EPC STORMWATER REVIEW COMMENTS ARE SHOWN IN ORANGE BOXES WITH BLACK TEXT

# PAINT BRUSH HILLS METROPOLITAN DISTRICT SCENIC VIEW AT PAINT BRUSH HILLS POND MODIFICATIONS

MAY 2022

SCENIC VIEW AT PAINT BRUSH HILLS POND MODIFICATIONS, RGA PROJECT NO. 1070.0022

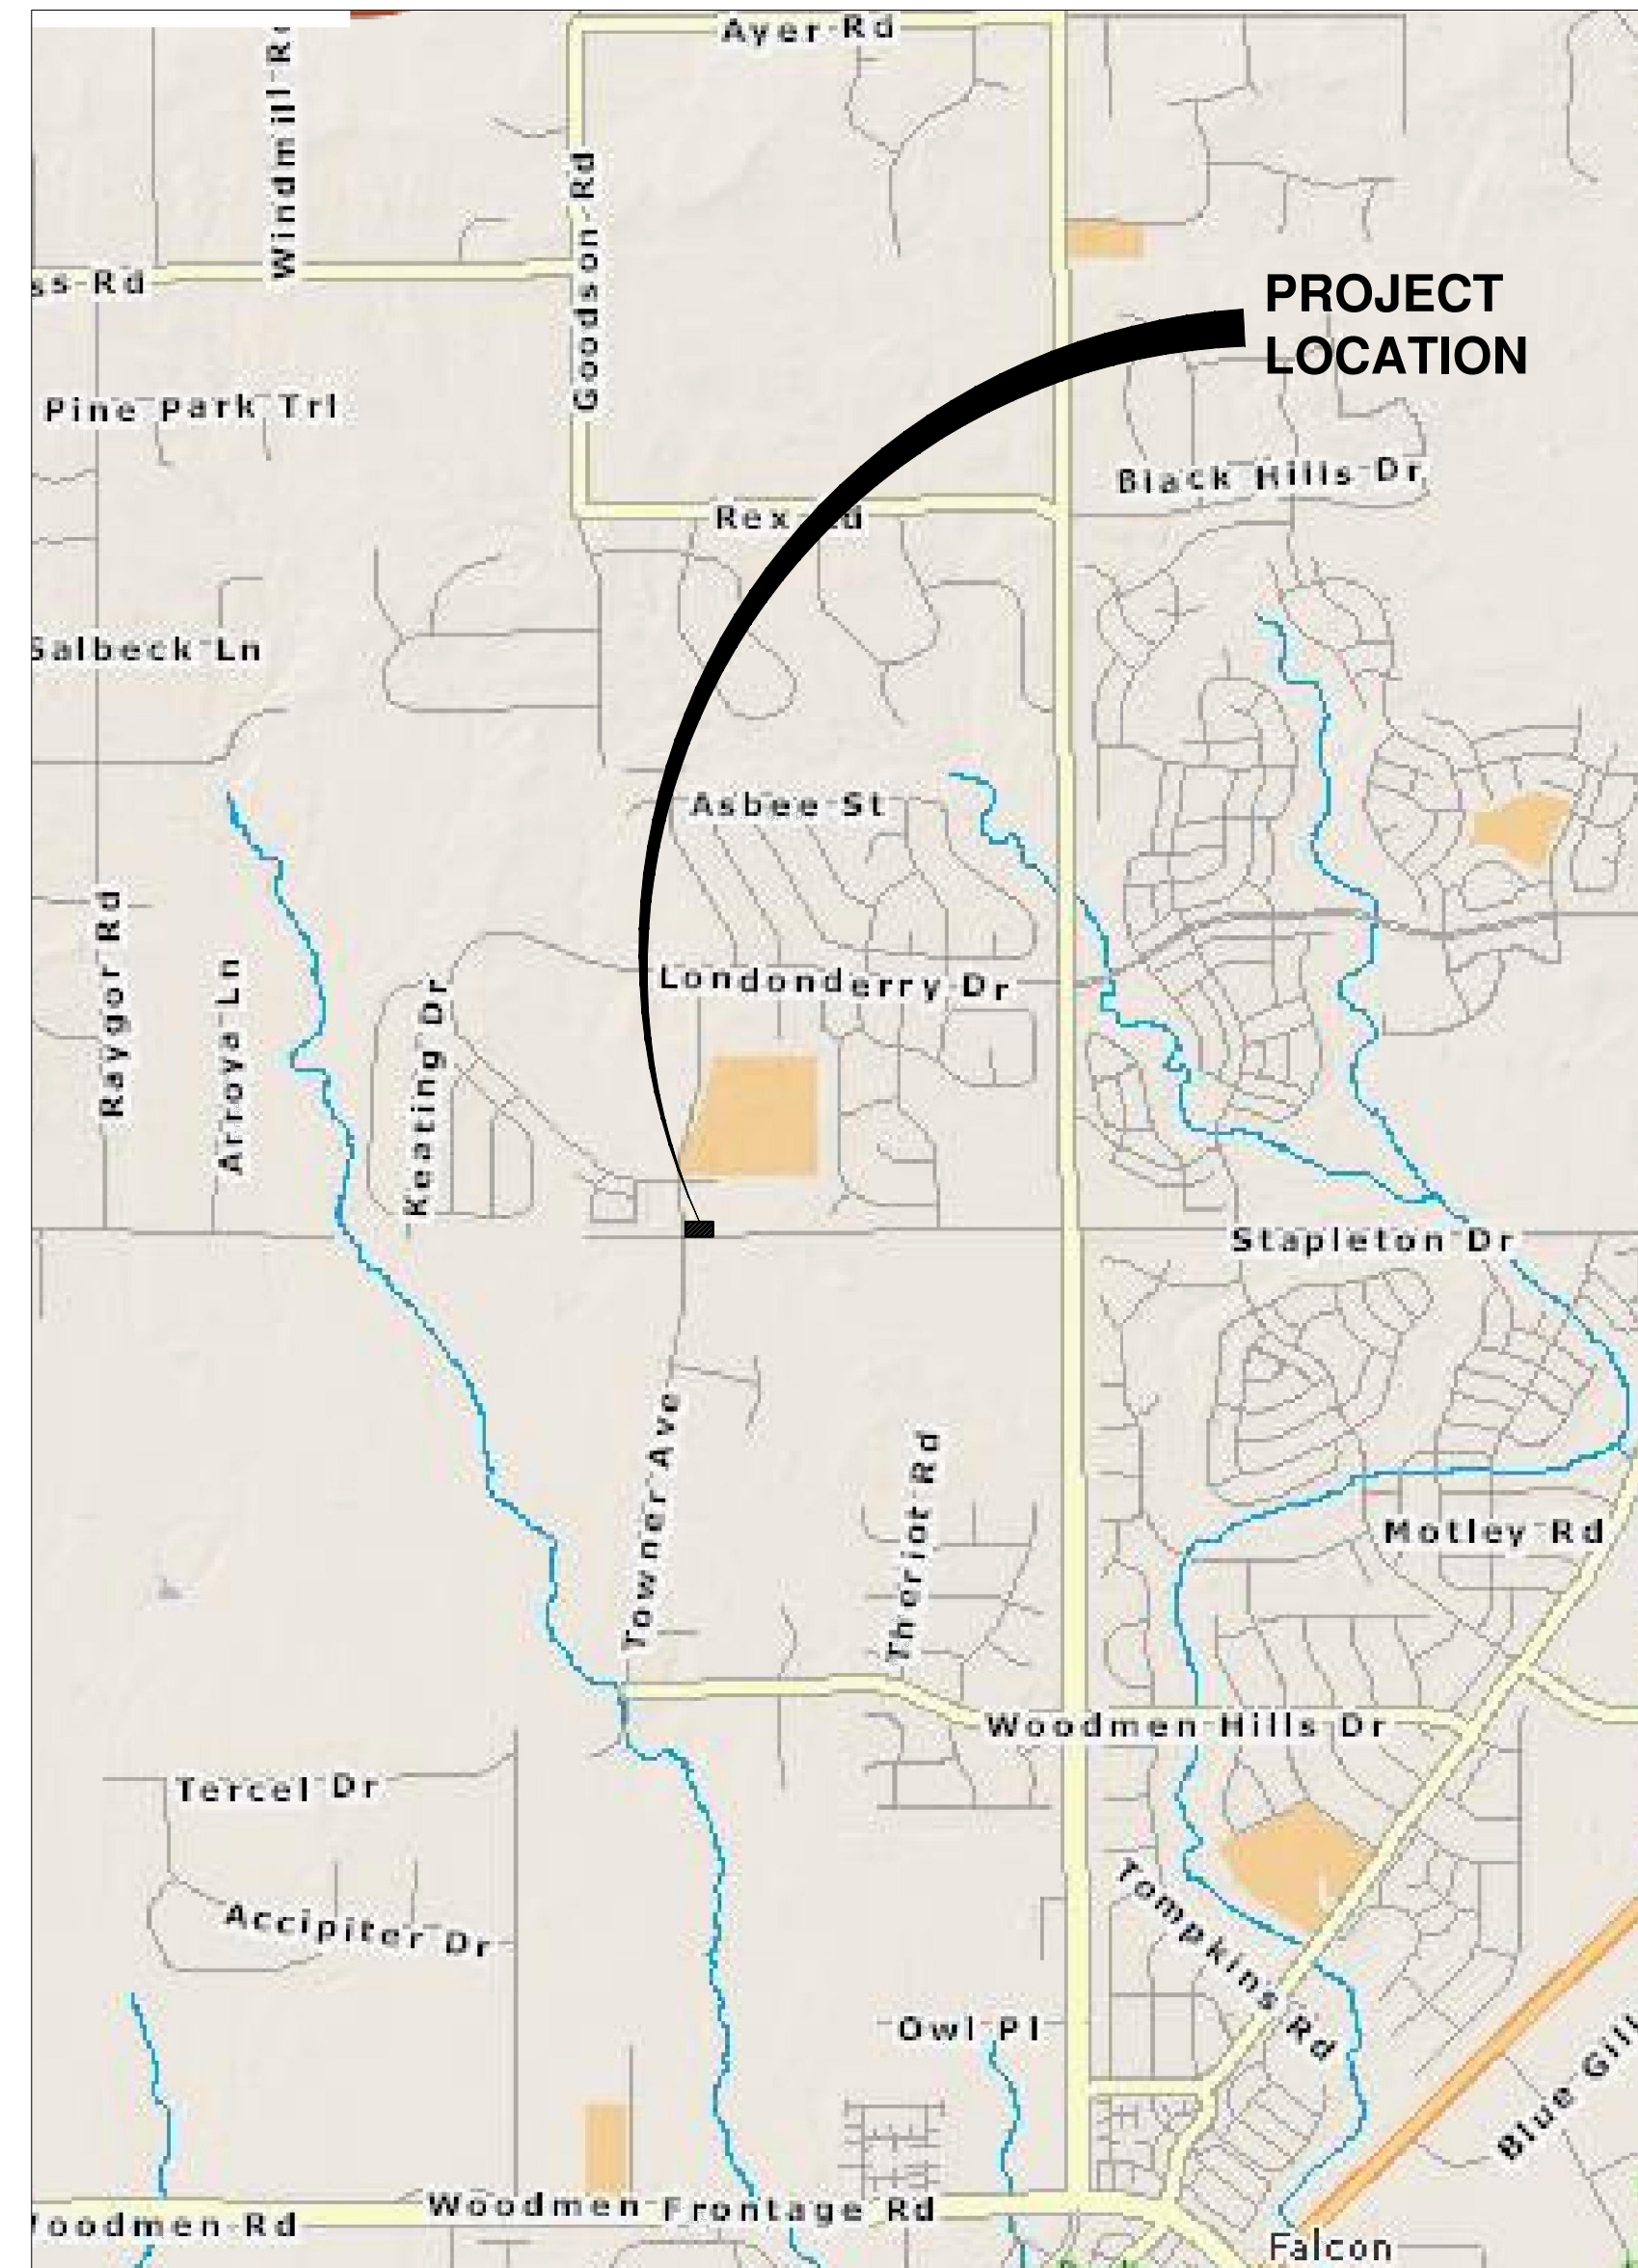
Please add signature blocks for construction drawings (GEC Items gg, ii, and jj):

Add PCD File No.  
CDR-229

Remove note.

<b>SCENIC VIEW AT PAINT BRUSH HILLS DETENTION POND MODIFICATIONS</b>		<b>GENERAL NOTES</b>	
DRAWN BY: JGS		DESIGNED BY: GEW	
JOB NUMBER: 1070.0022			
DATE: MAY 2022			
SCALE: N/A			
DRAWING NAME: GENERAL NOTES			
SHEET NO: 2 of 8

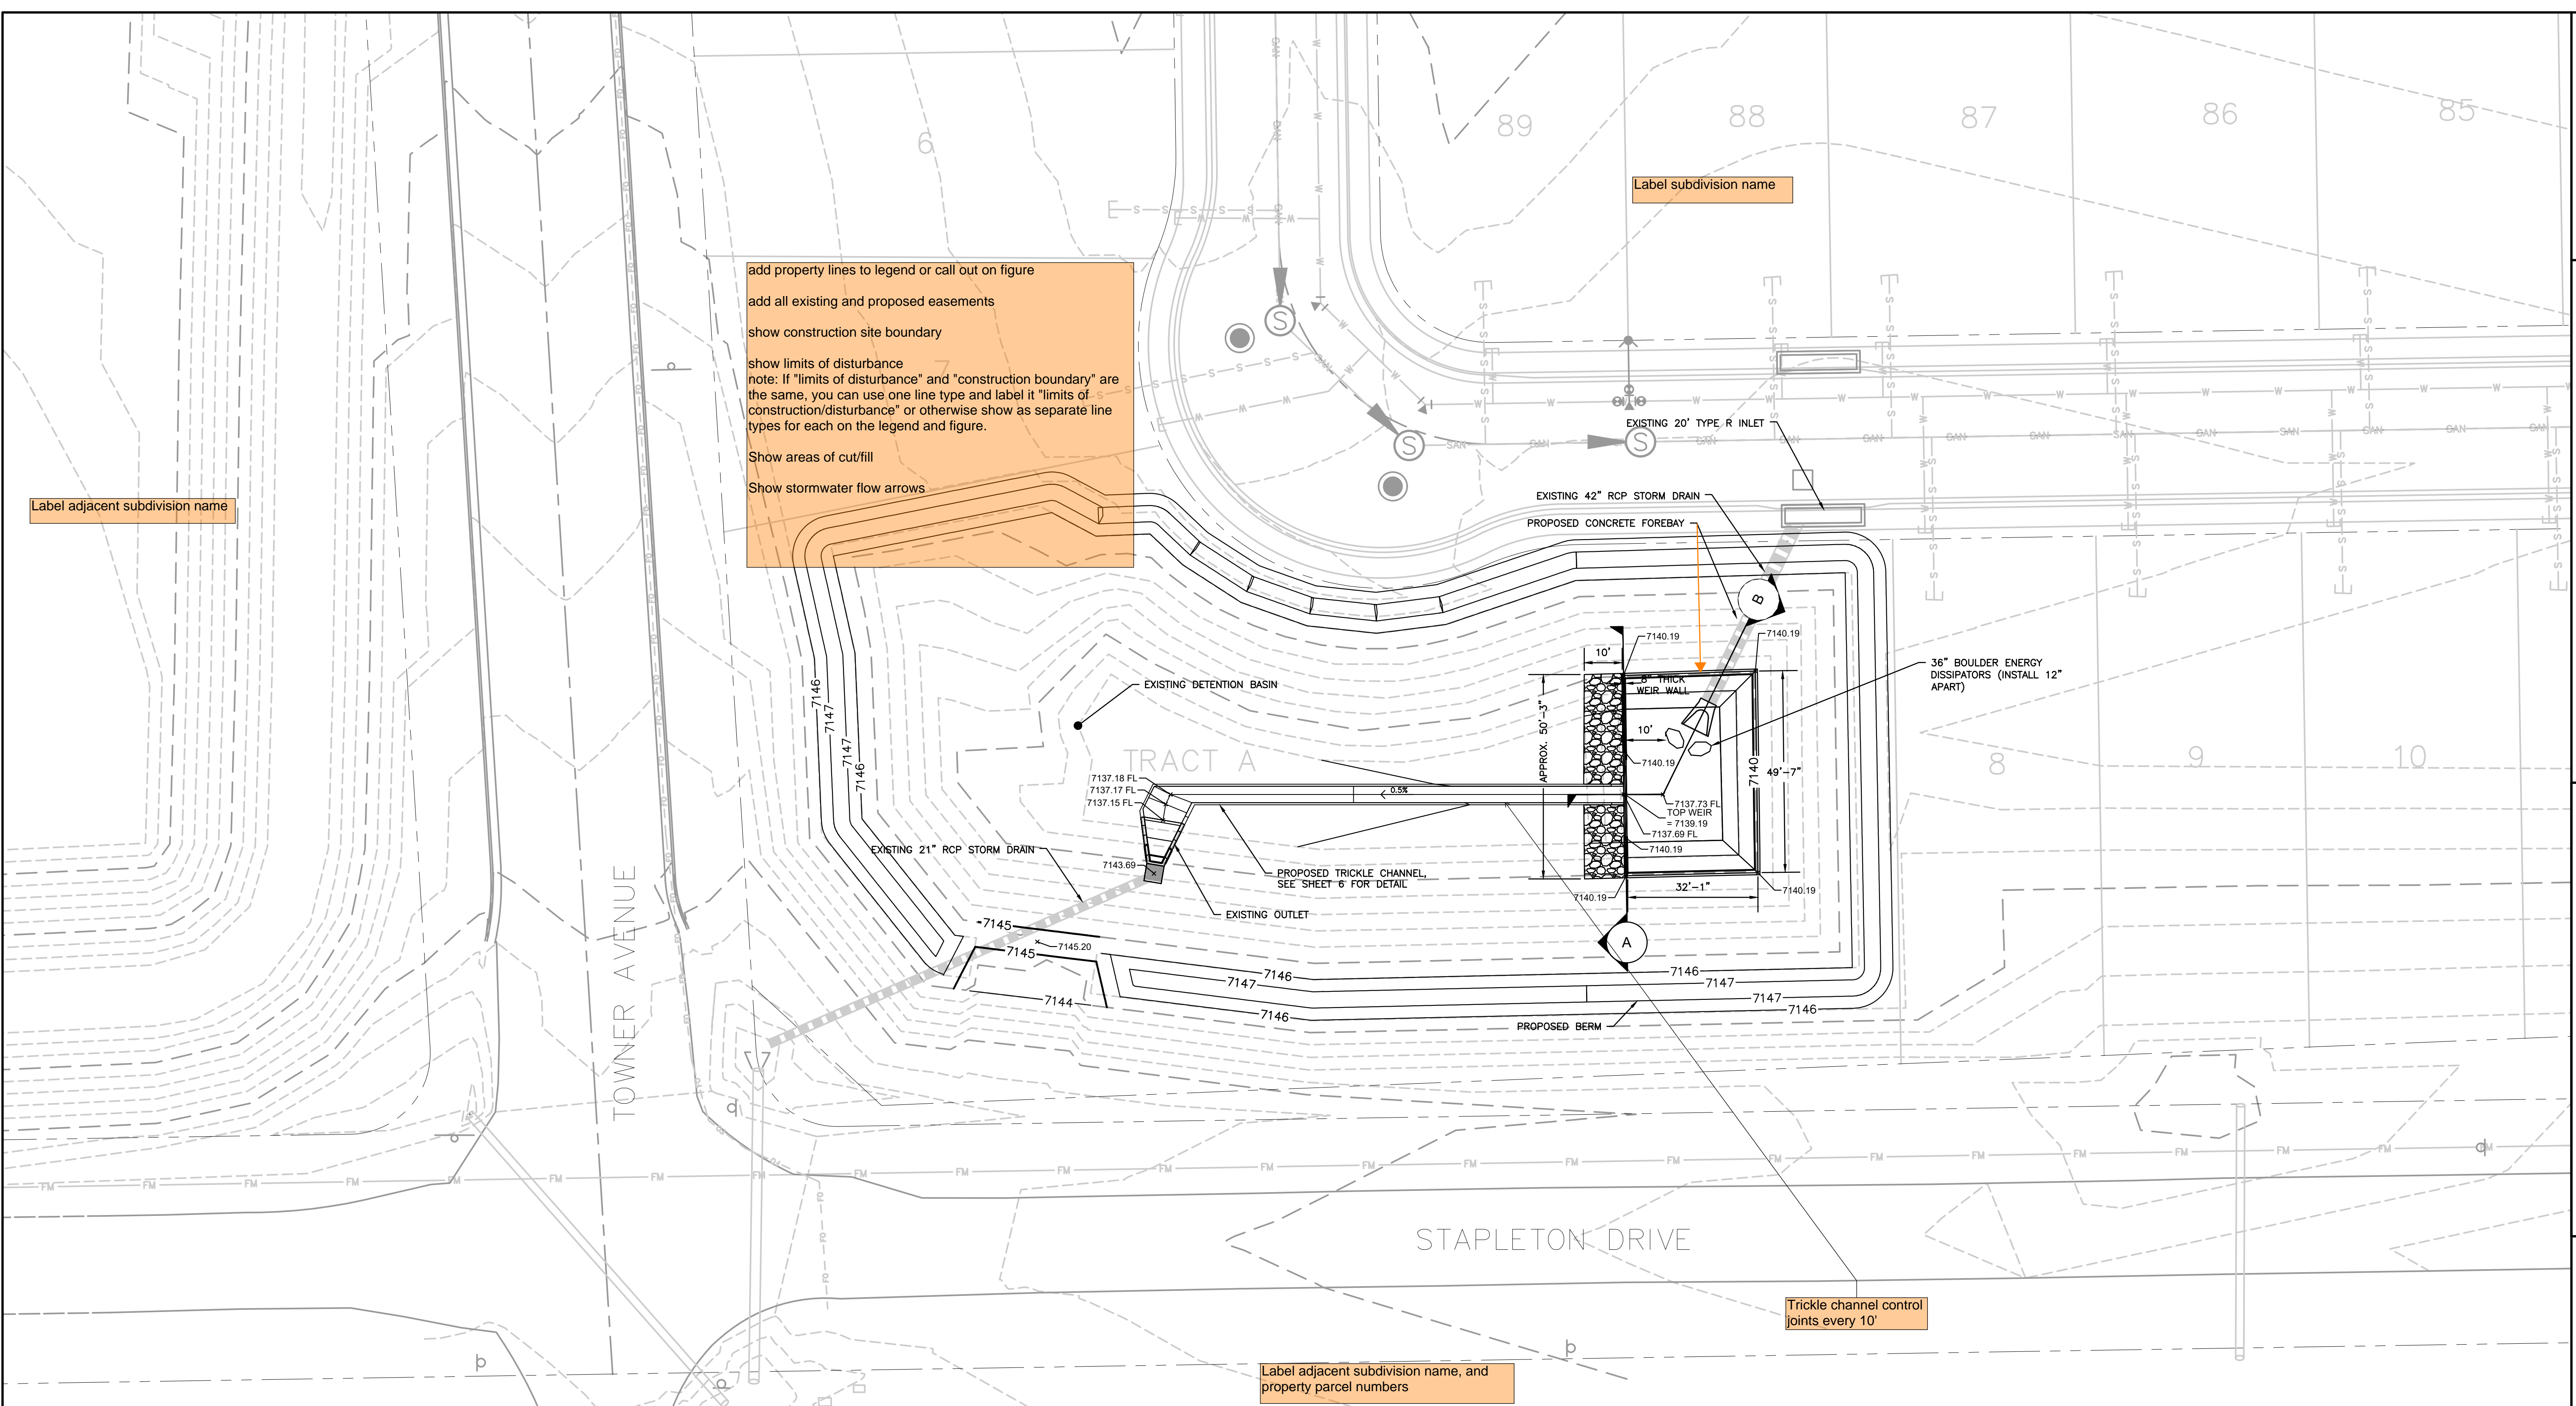
To comply with the SWMP Checklist Item 17f, please add a note stating no batch plants will be utilized onsite.  
 Add a note about existing vegetation

Update to include the entire EPC Construction notes. See document.
